World Forum for Harmonization of Vehicle Regulations

1958 Agreement – Consideration of draft amendments to existing Regulations submitted by GRPE

Proposal for Supplement 6 to the 05 series of amendments to Regulation No. 49 (compression ignition and positive ignition (LPG and CNG) engines)

Submitted by the Working Party on Pollution and Energy*

Figure 1
Illustration of the HC limits in the case of a dual-fuel engine operating in dual-fuel mode during the ETC cycle (natural gas dual-fuel engines)

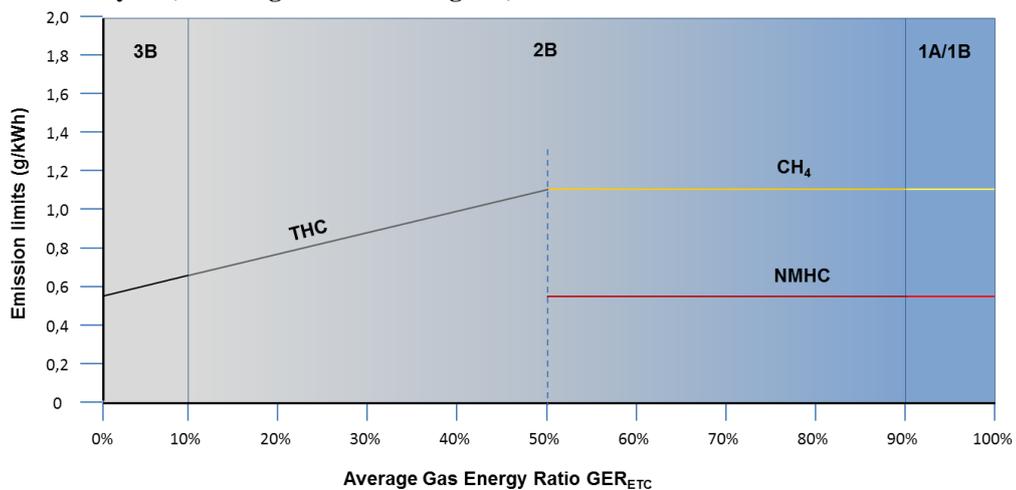
$NMHC_{NG}$ is the NMHC emission limit over the ETC test-cycle and made applicable to NG engine in rows B2 and C of table 2 of paragraph 5.2.1 of this Regulation.

$CH4_{NG}$ is the CH_4 emission limit over the ETC test-cycle and applicable to NG engine in rows B2 and C of table 2 of paragraph 5.2.1 of this Regulation.

Figure A2.1.1

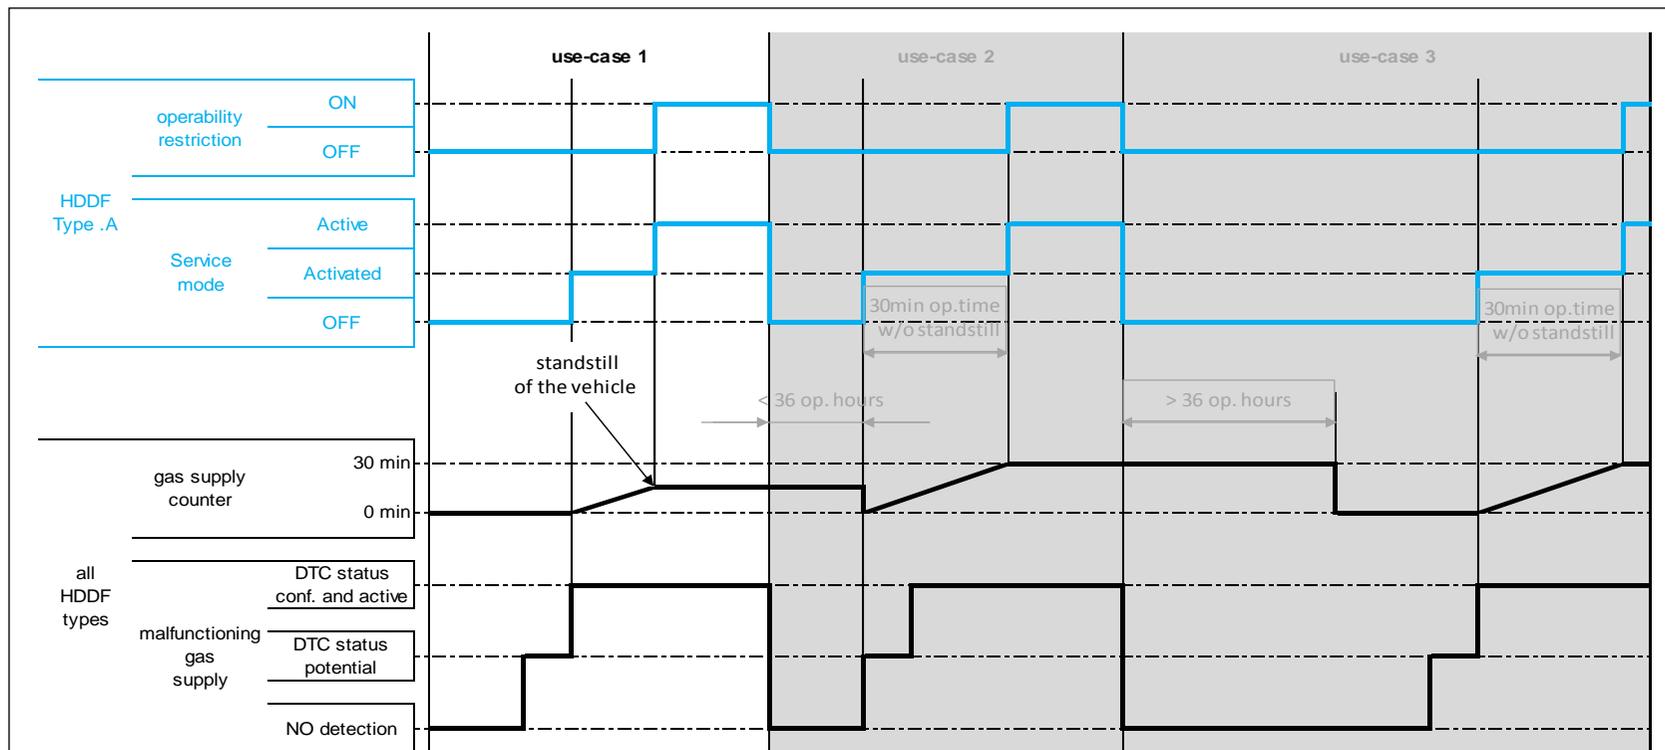
Illustration of the gas supply counter mechanism (Type 1A dual-fuel engine (HDDF)) - use-case 1

A malfunction of the gas supply is detected for the very first time.

The service mode becomes active and the vehicle speed is limited to 20 km/h (see paragraph 4.2.2.1. of this annex).

The counter freezes at its present value.

Illustration of the gas supply counter mechanism (Type 1A dual-fuel engine (HDDF)) - use-case 2

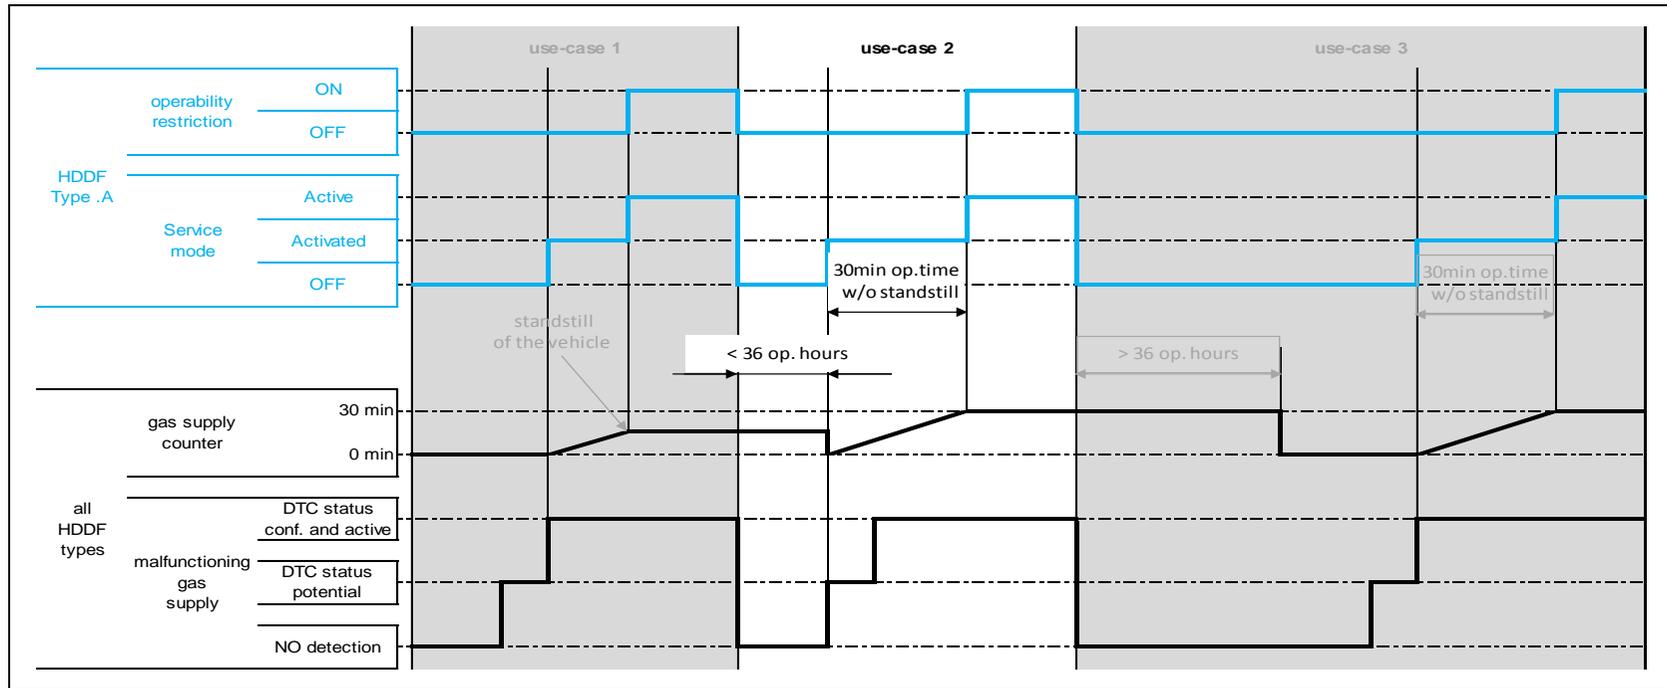
A malfunction of the gas supply is detected while the gas supply malfunction counter is not at zero (in this use-case it indicates the value it reached in use-case 1 when the vehicle became standstill).

The counter freezes at a value of 30 minutes operating time.

Figure A2.1.3

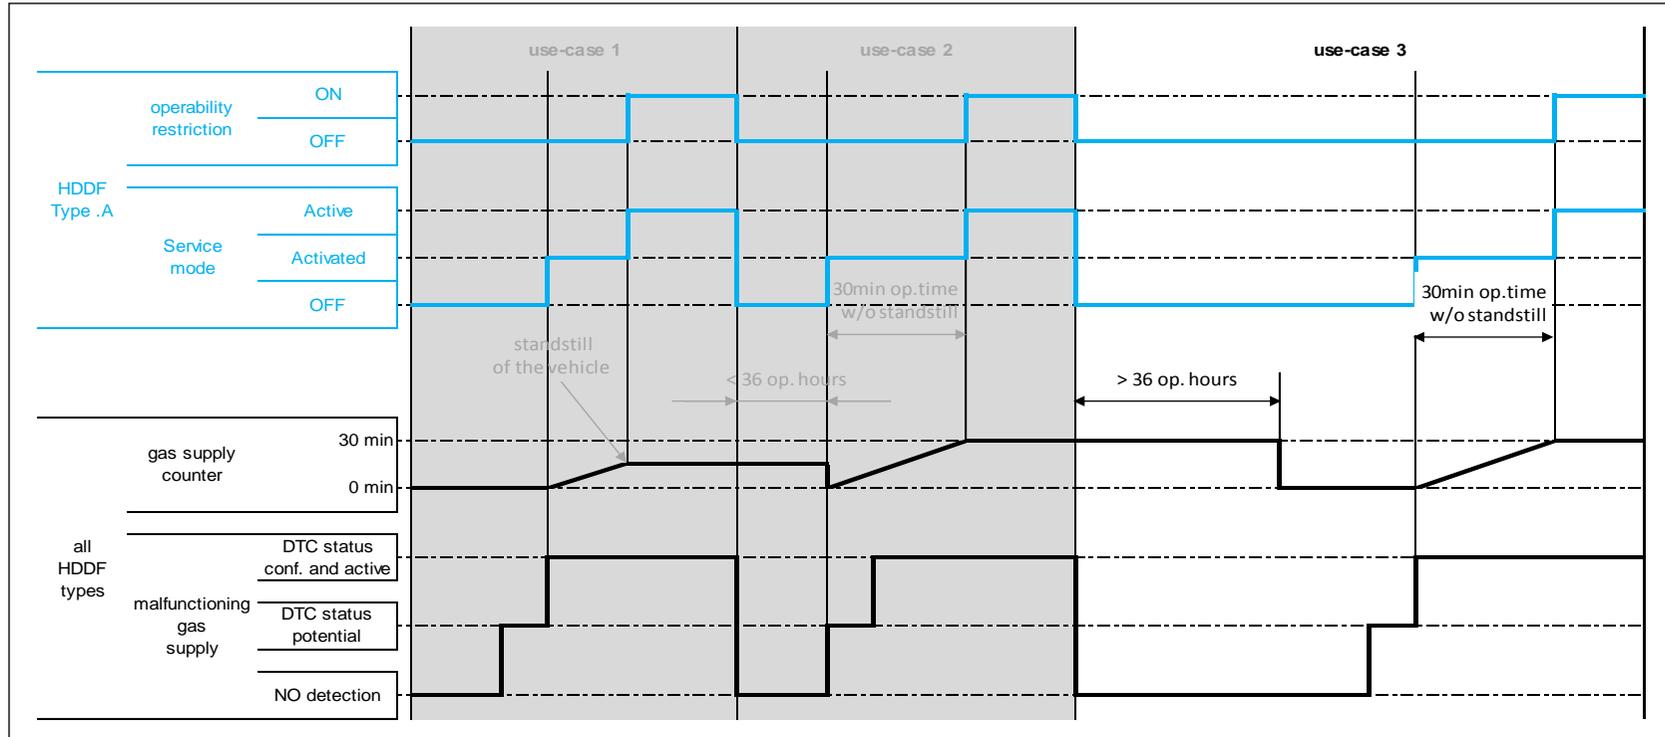
Illustration of the gas supply counter mechanism (Type 1A dual-fuel engine (HDDF)) - use-case 3

After 36 operating hours without detection of a malfunction of the gas supply, the counter is reset to zero (see paragraph A.2.1.2.3.2.1).

Figure A2.2

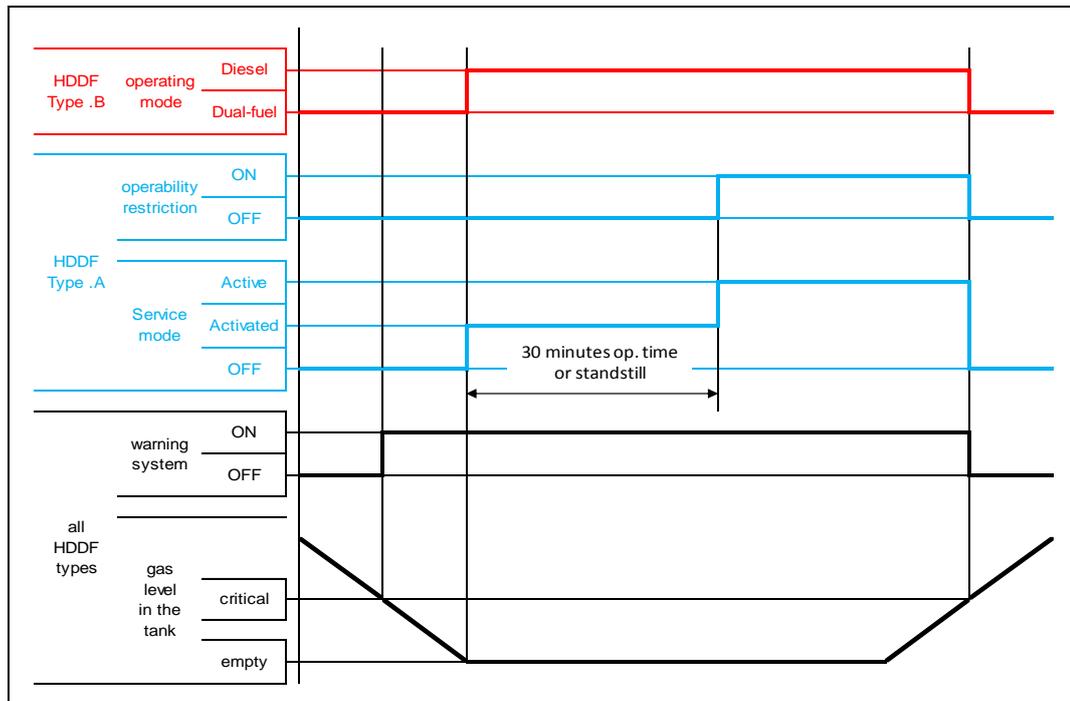
Figure A2.2 gives an illustration of the events occurring in the case of a dual-fuel vehicle when a gas tank becomes empty through one typical use-case.

Illustration of the events occurring in case of an empty gas tank of a dual-fuel engine/vehicle (HDDF)

Figure A2.3

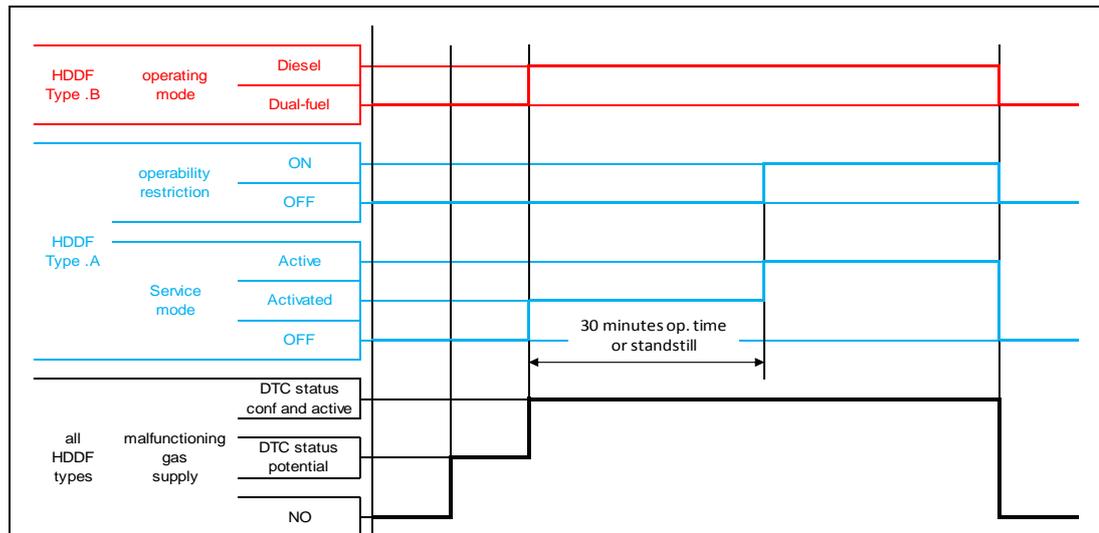
Figure A2.3 gives via one typical use-case an illustration of the events occurring in the case of a malfunction of the gas supply system. This illustration should be understood as complementary to that given in paragraph A.2.1 and dealing with the counter mechanism.

Illustration of the events occurring in case of a malfunctioning gas supply system of a dual-fuel engine/vehicle (HDDF)
